ADDENDUM NO. 2

HANOVER CENTRAL HIGH SCHOOL FOOTBALL FIELD & TRACK IMPROVEMENTS

ADDENDUM TWO

5. Sheet C-5.0

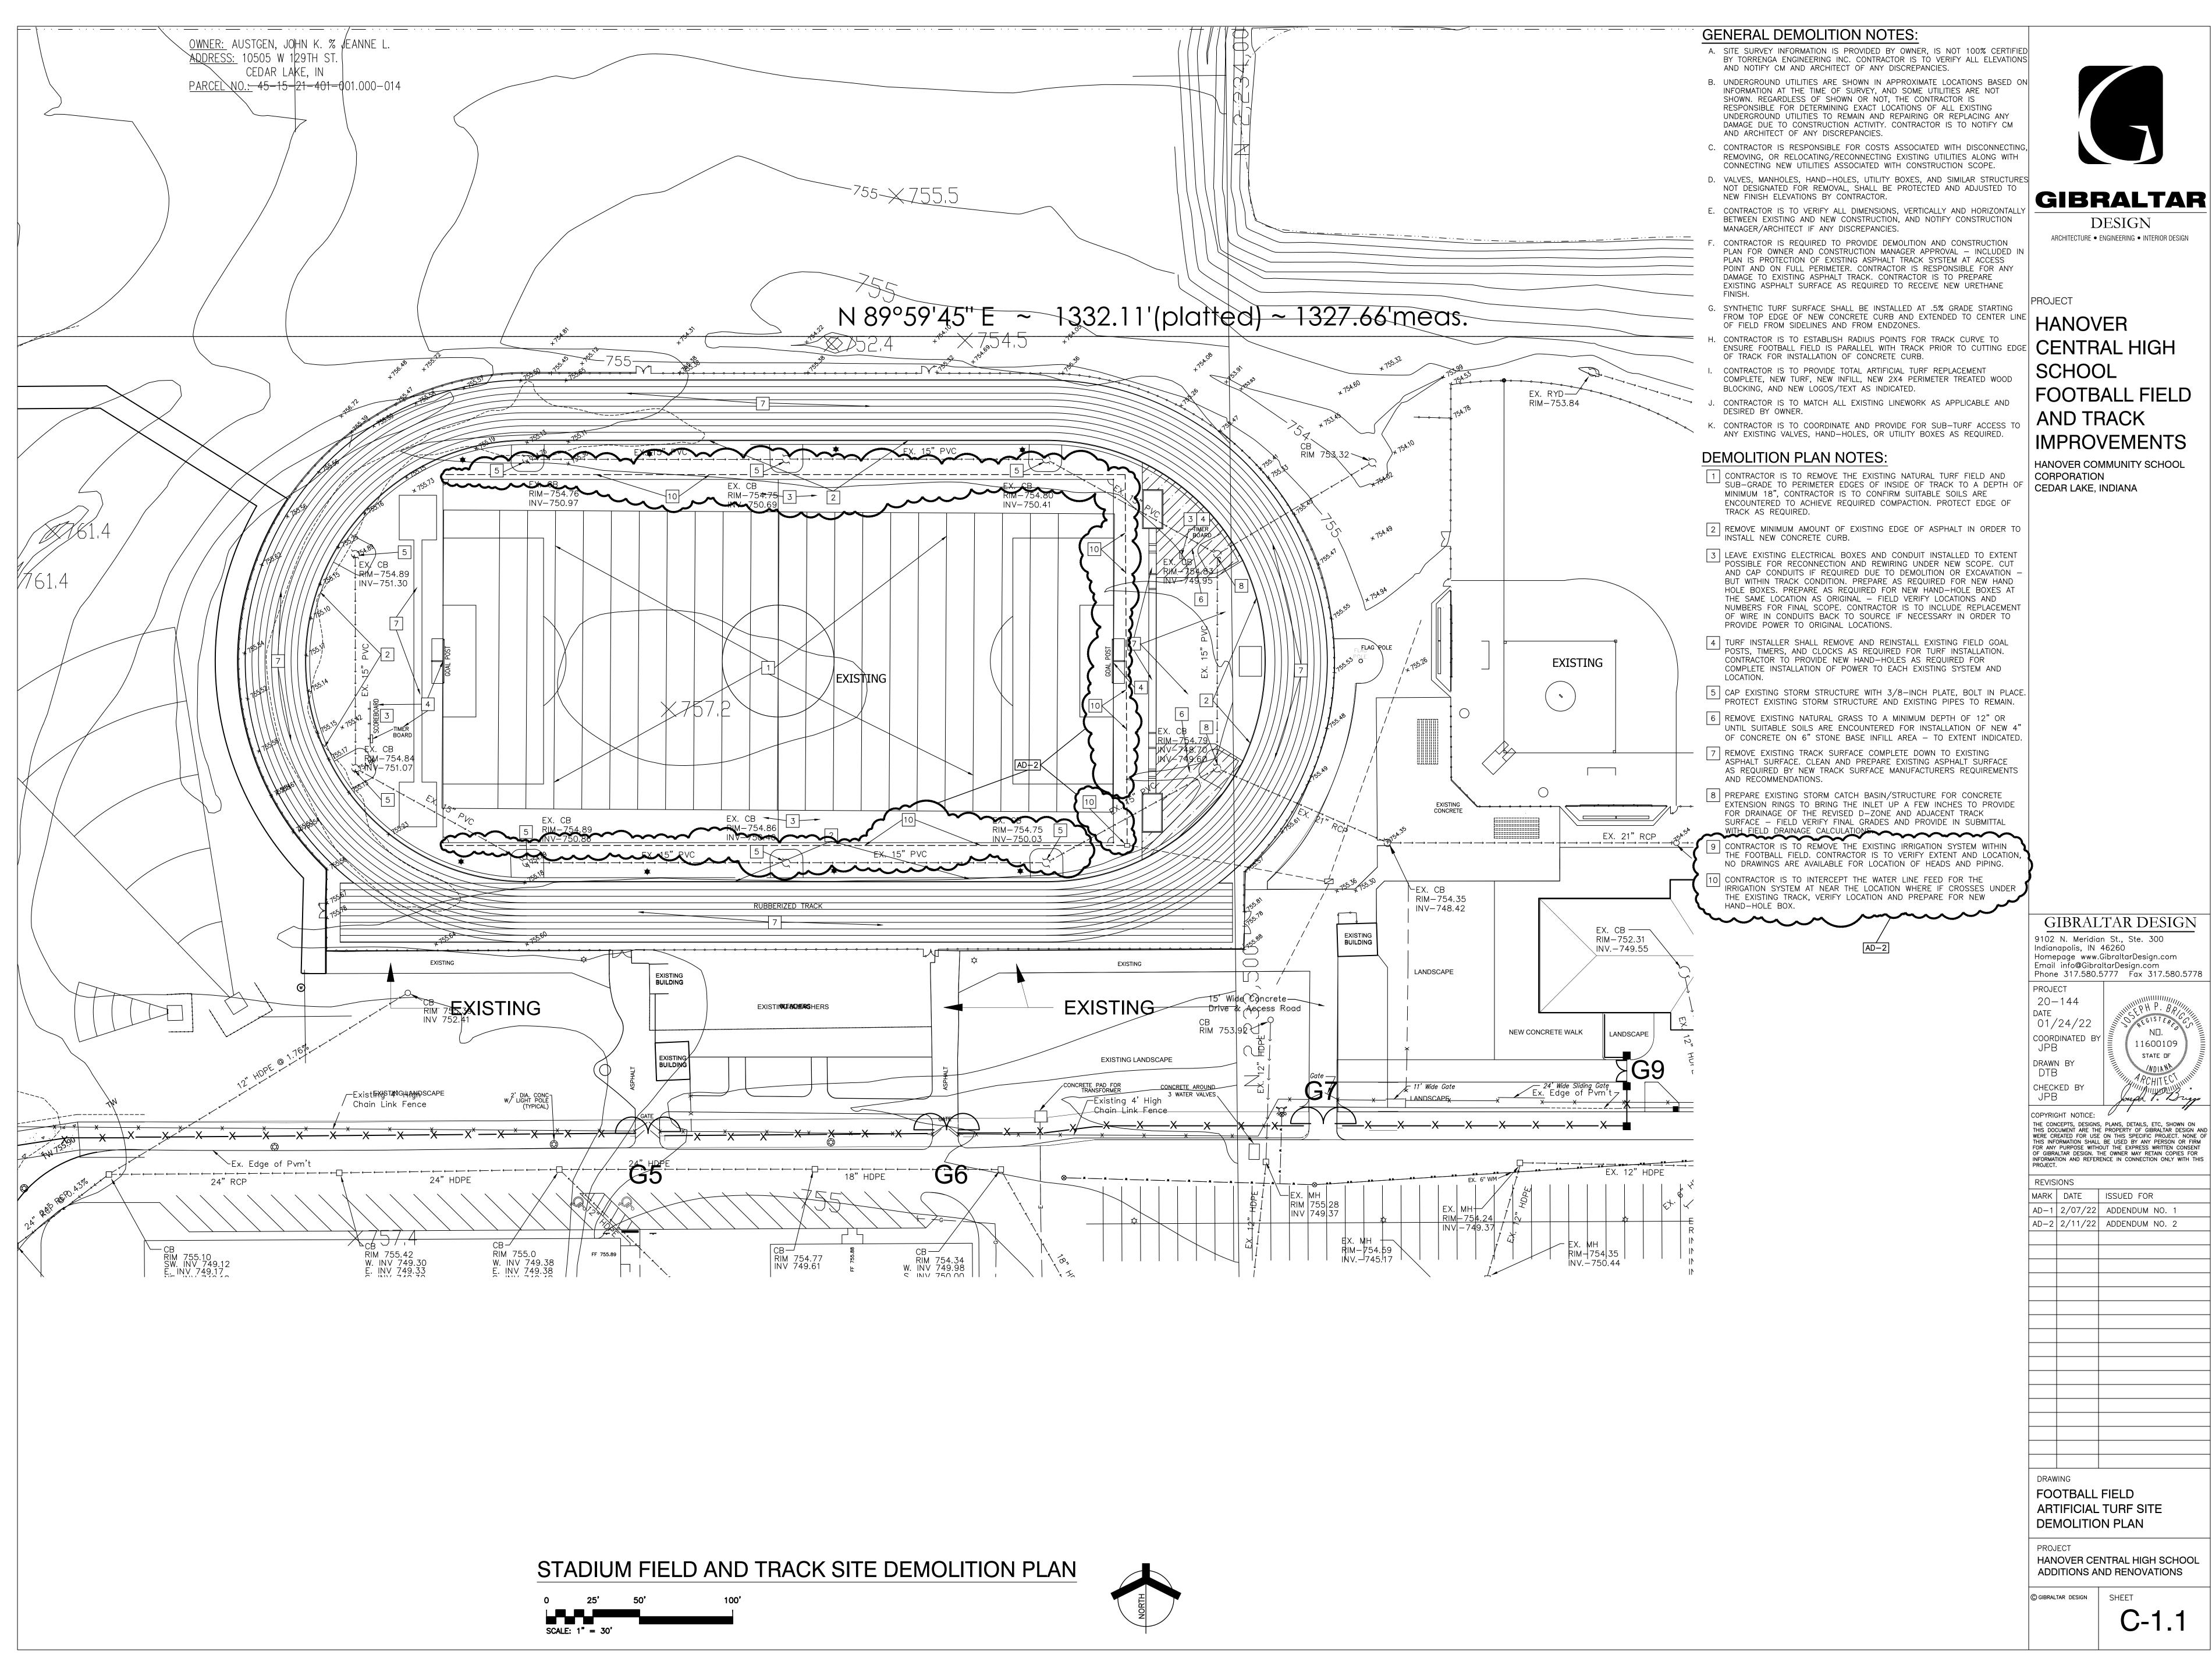
- A. Refer to revised full size drawing, included in this Addendum, for revisions.
 - 1. Clarification of concrete slab infill requirements and depth of slab.

- 2. Additional Hand-Hole design requirements for electrical boxes to be located in place of the existing hand-holes and the addition of two Microphone Hand-Hole boxes with power receptacle requirements being added to the project.
- 3. Addition of a Valve Box Detail for the interception of the water line noted above.

C-1.1

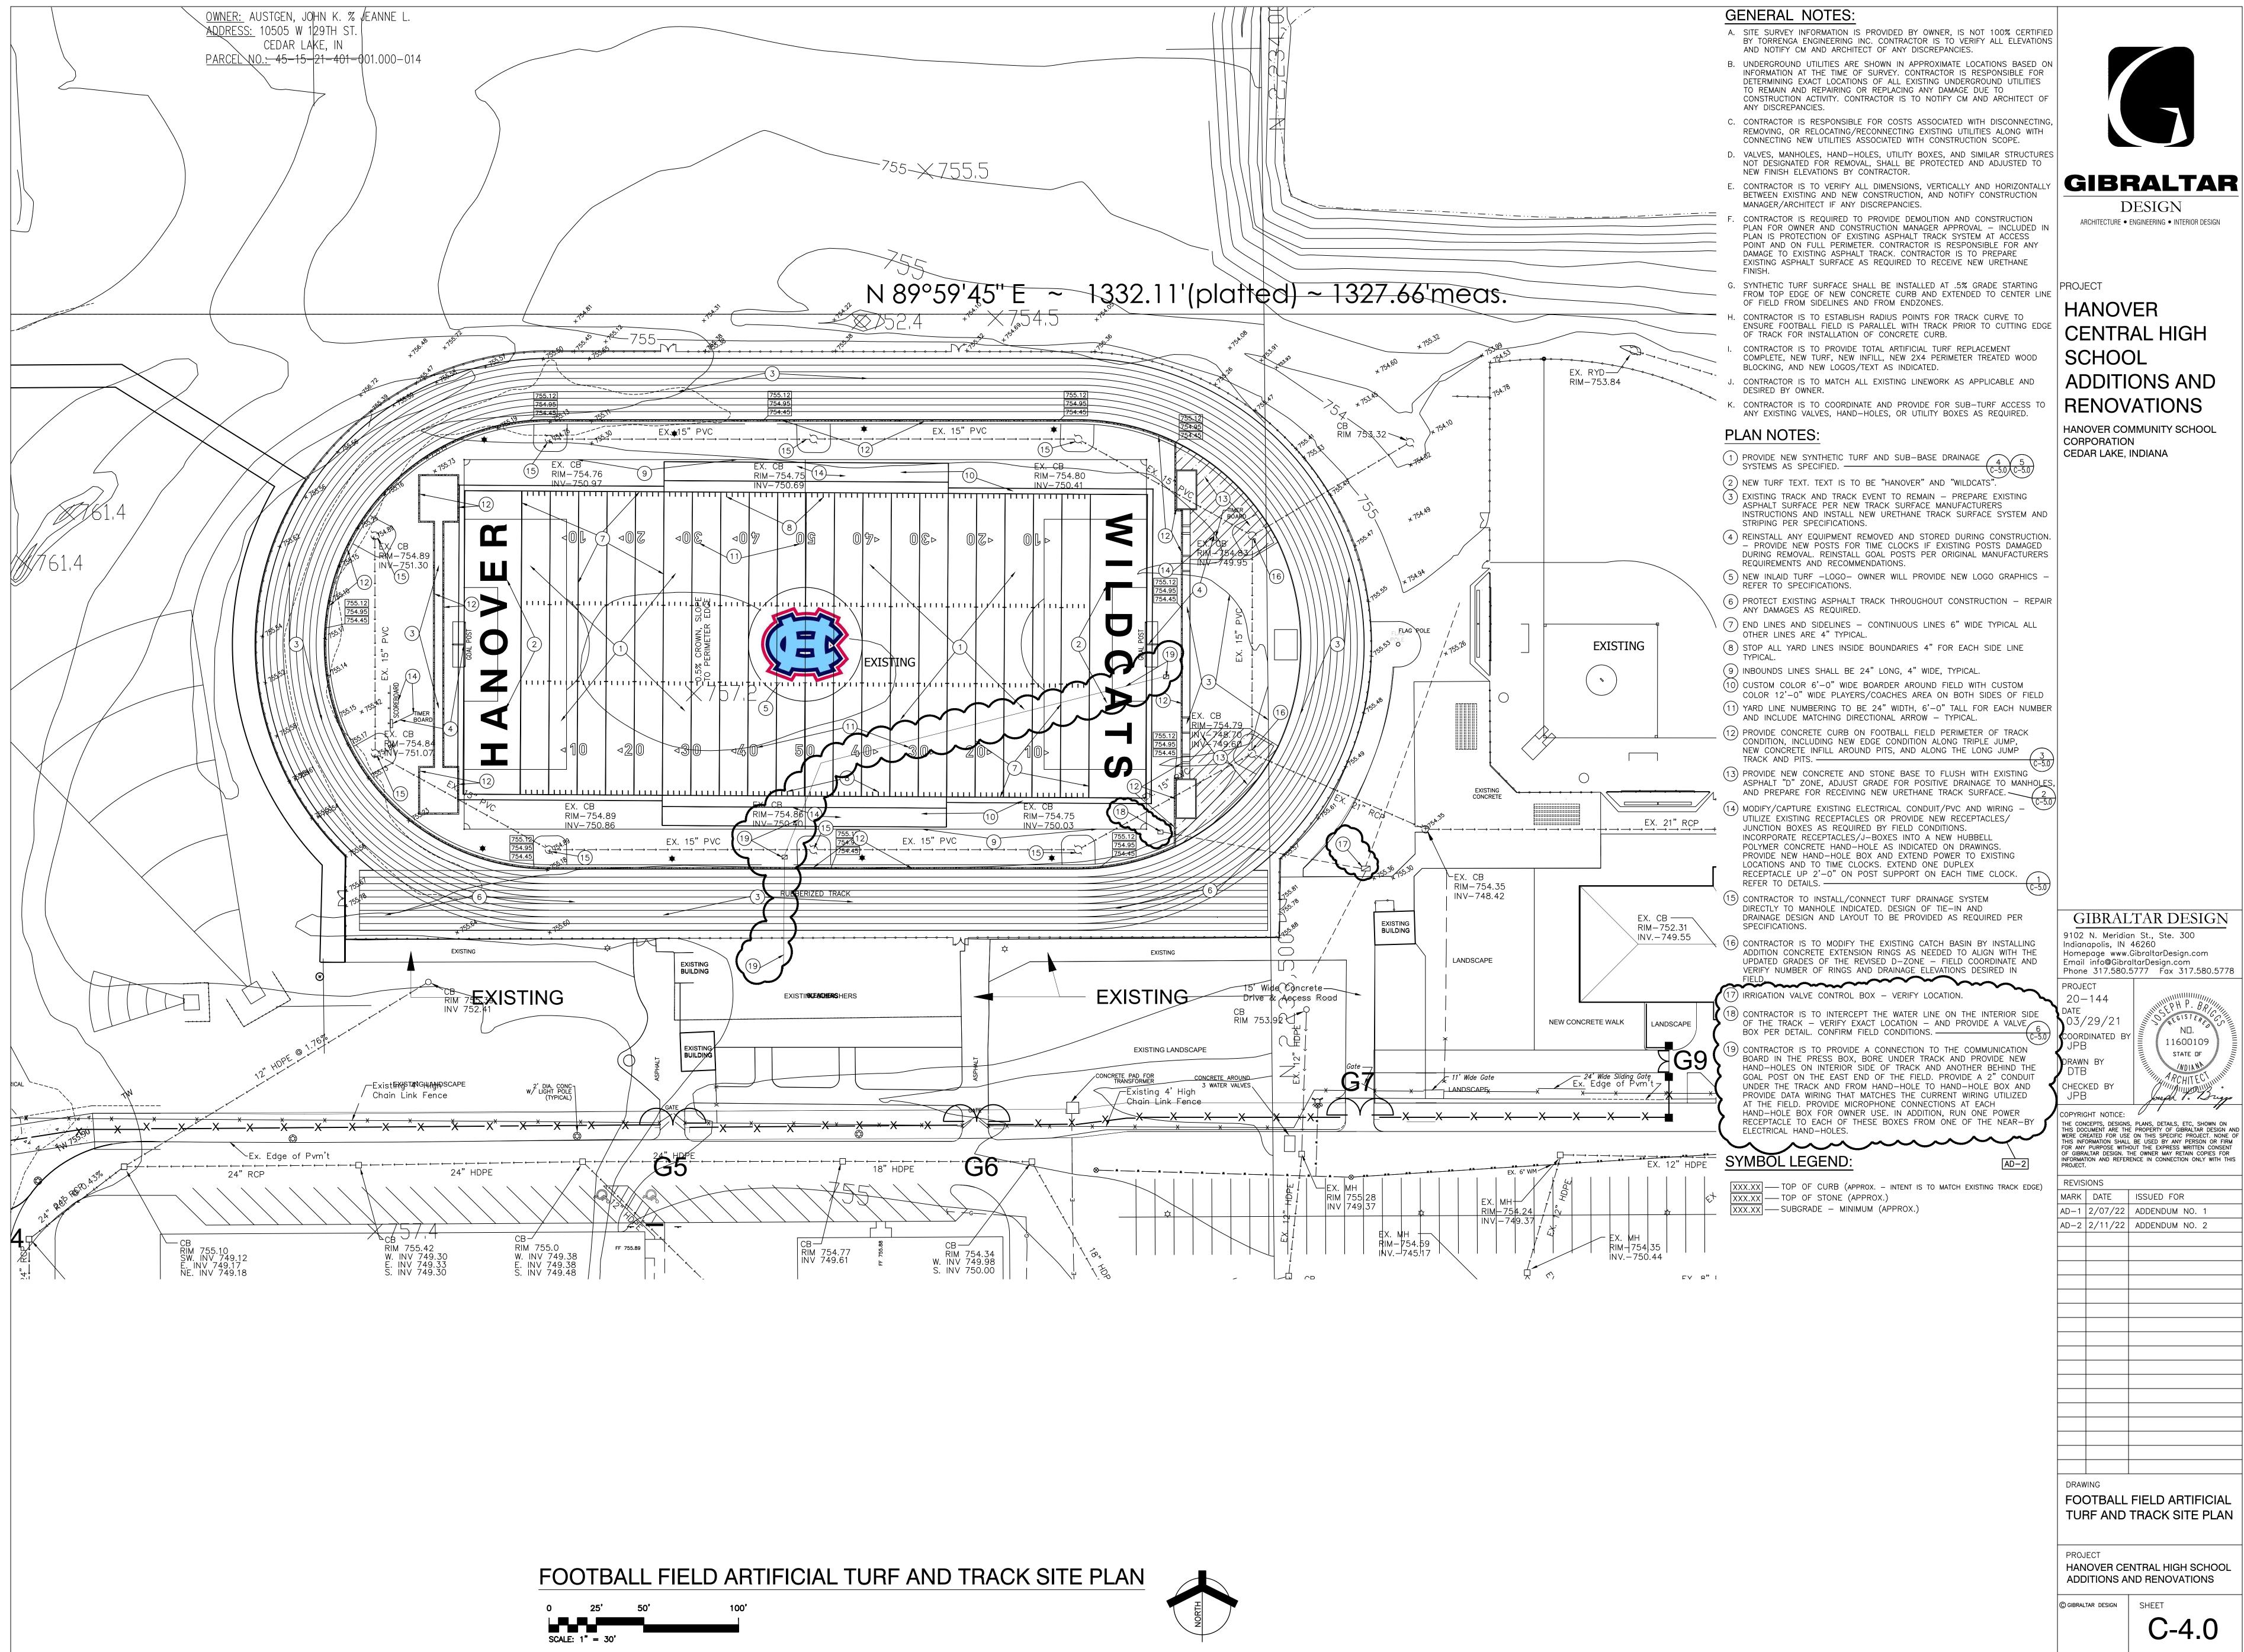
- A. Refer to revised full size drawing, included in this Addendum, for revisions.
 - 1. Addition of demolition of irrigation lines within the track area with the intercepting of the water line accordingly.

C-4.0

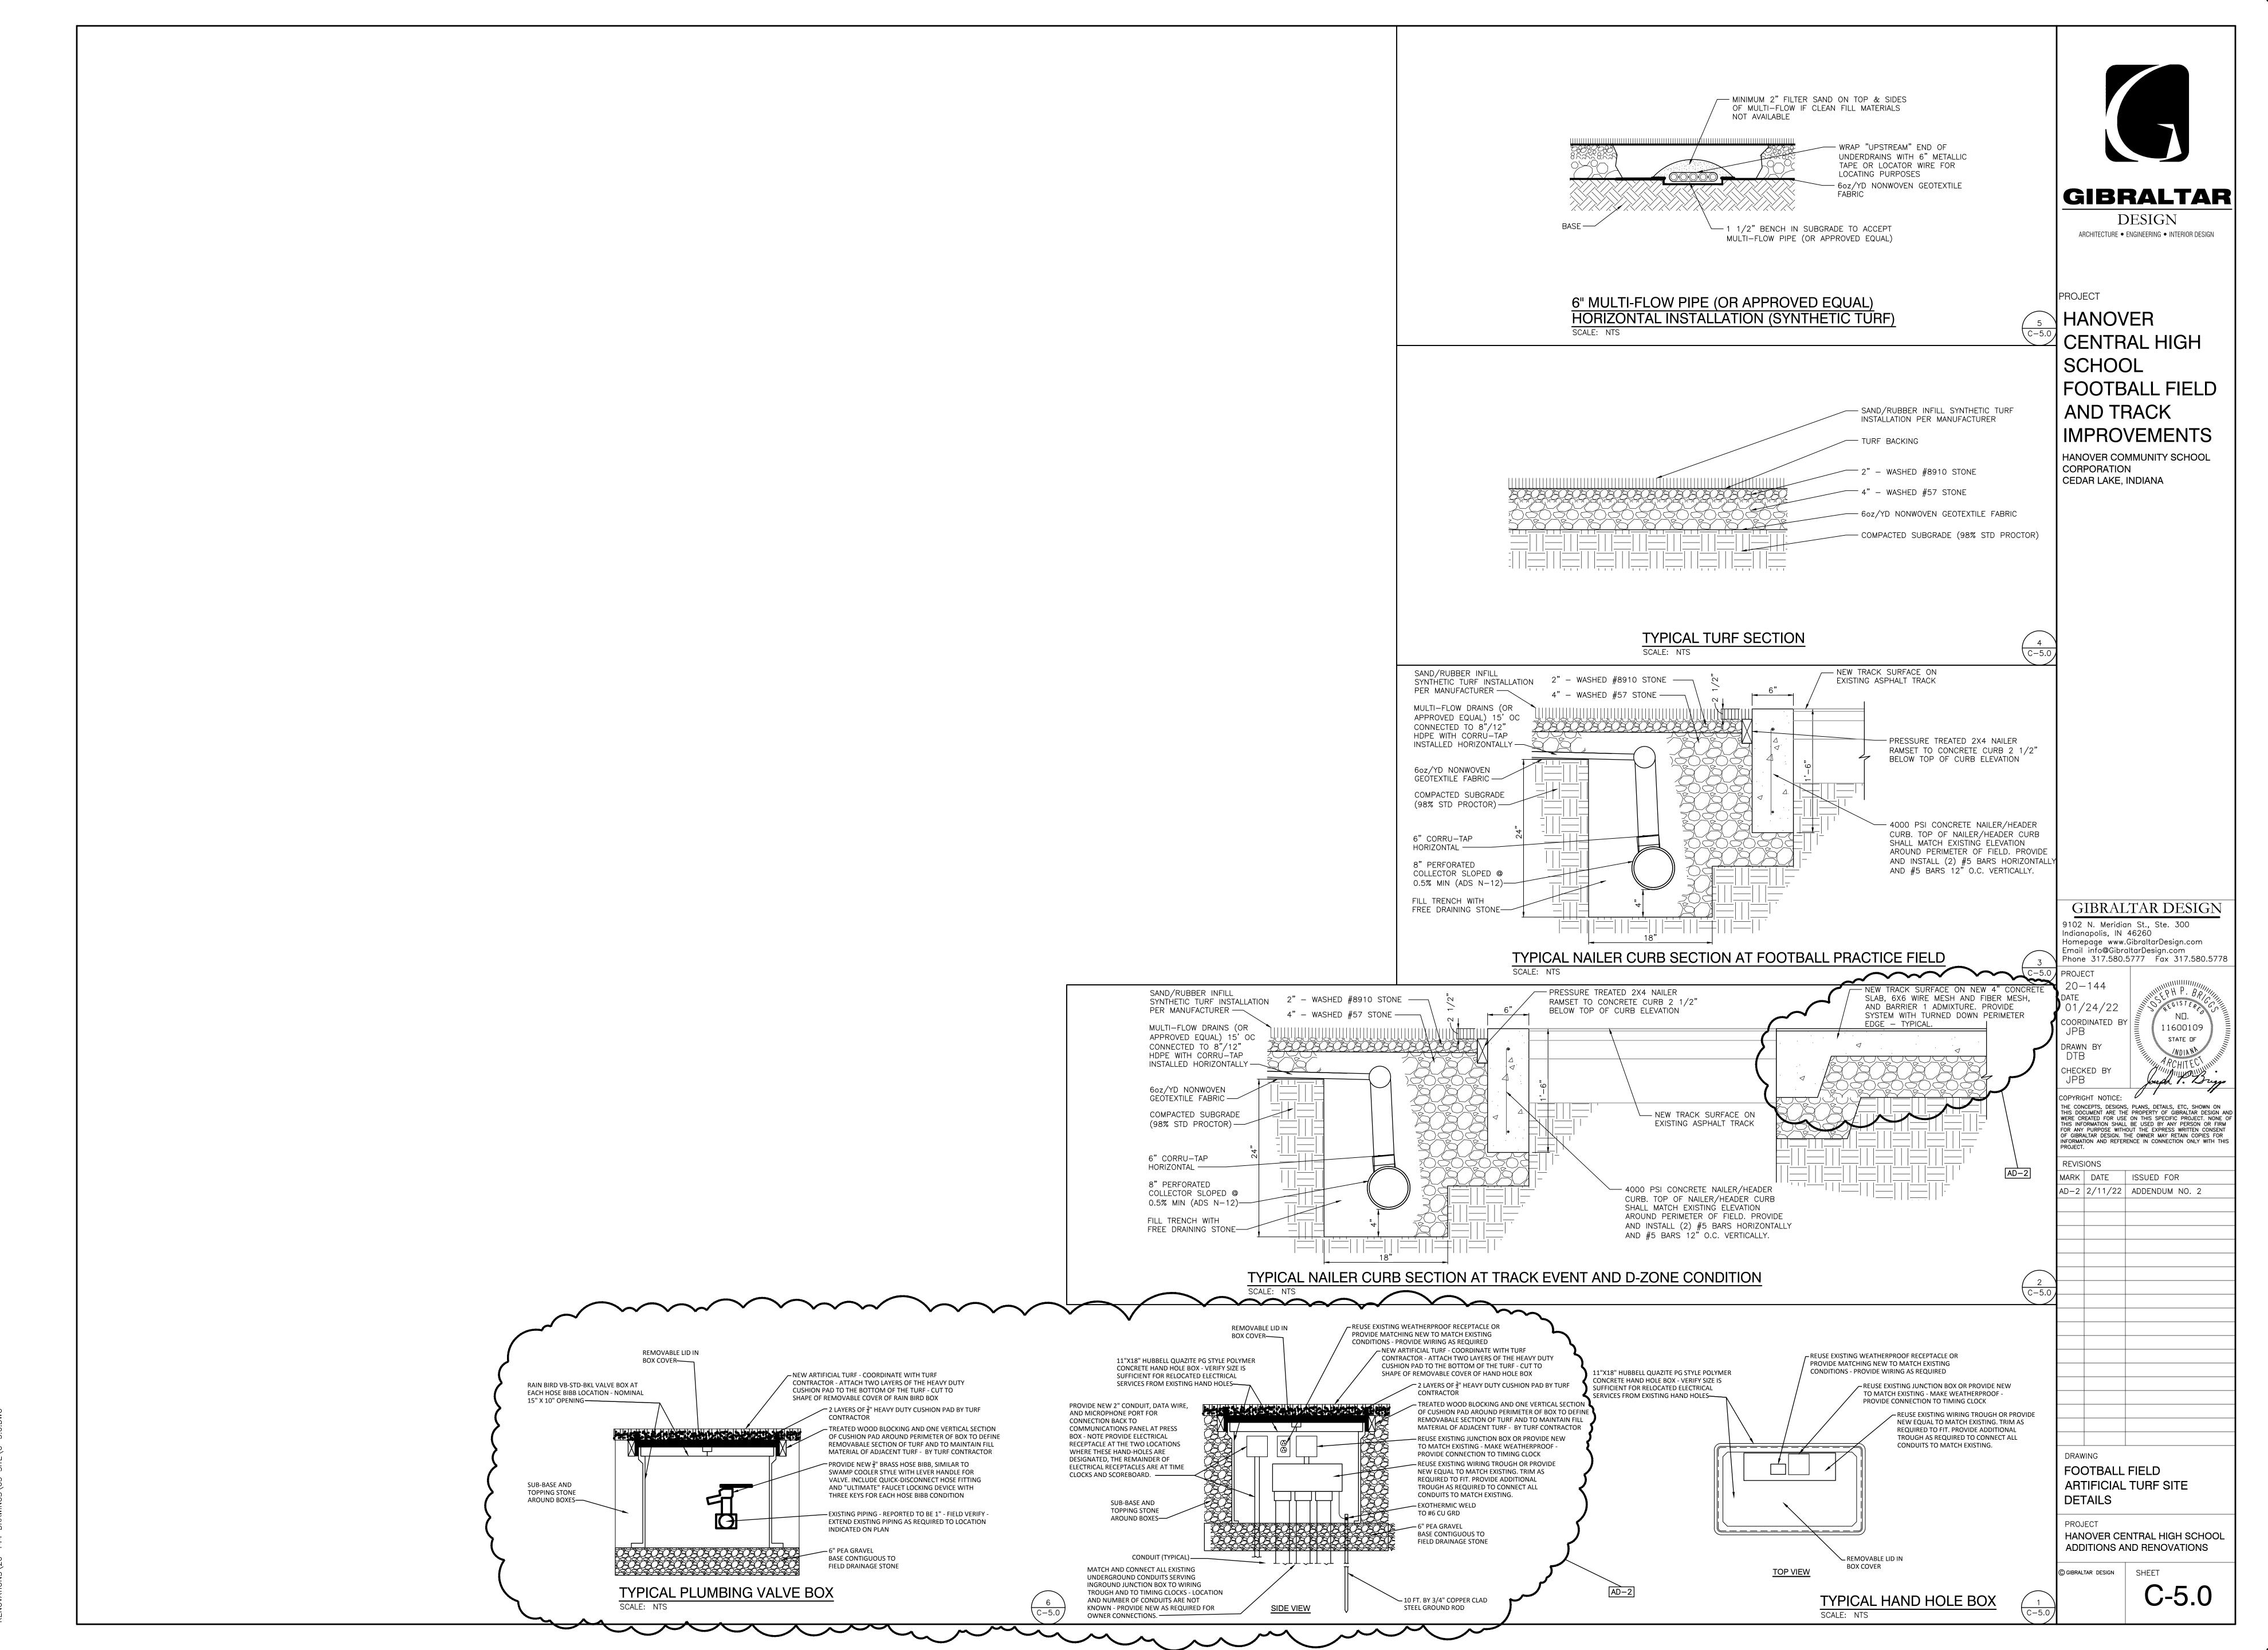
- A. Refer to revised full size drawing, included in this Addendum, for revisions.
 - 1. Clarification of where the irrigation systems valve control box is located.
 - 2. Clarification of intercepting the water line on interior of track side coordinate and confirm location and installation of a valve box.
 - 3. Addition of power and Microphone hand-holes connected to the Press Box to two field locations.
